CRIME IMPACT STATEMENT

Former Particular Baptist Church, 35 Rochdale Road
133 No. Apartments & Ground Floor Commercial Unit

VERSION A: 20th January 2025

REFERENCE: 2024/0441/CIS/01

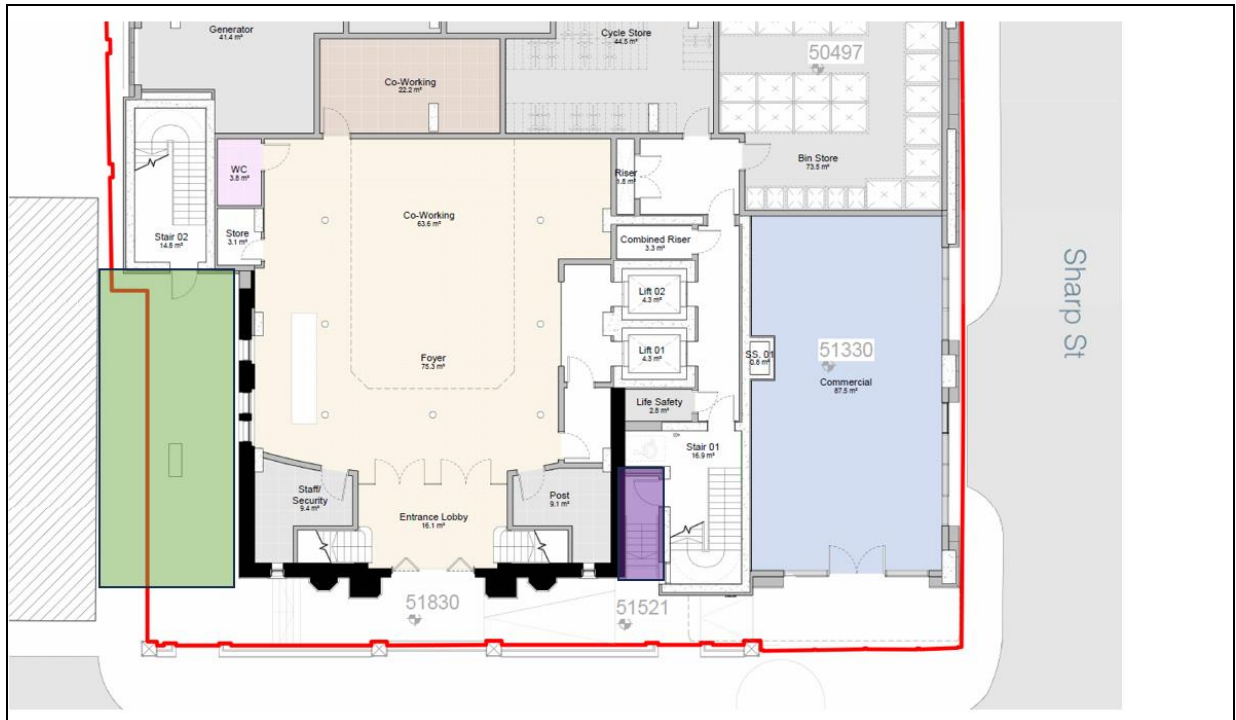
- 3.3.1 The proposed retention of the main facade of the church and some of the existing church building will potentially create areas between the proposed building and retained existing church building (highlighted in green). These areas, if not secured, could generate criminal and antisocial behaviour - particularly if they are sheltered by the building above. Misuse of similar spaces in the city centre areas and nearby include loitering, drug/alcohol consumption, public urination, and vagrancy, to the detriment of residents. To reduce the potential for misuse the spaces between the existing building, the adjacent building under development and the proposed building should be secured to prevent unauthorised access.

- 3.3.2 There is a recessed doorway highlighted in purple above. Similar recessed doors in the city centre area attract misuse (similar to the above) and should be avoided where possible. In this case the steps to the entrance could also generate loitering, increasing the risk of antisocial/criminal activity to the detriment of residents. Ideally, the recess should be omitted or should be gated to restrict access to unauthorised persons, if it is an escape route a panic bar could be installed on the inside to allow it to be used as an escape route.

- 3.3.3 If either of these spaces cannot be secured then they should be illuminated to a high standard, covered by monitored CCTV, and include tactile paving to deter loitering.
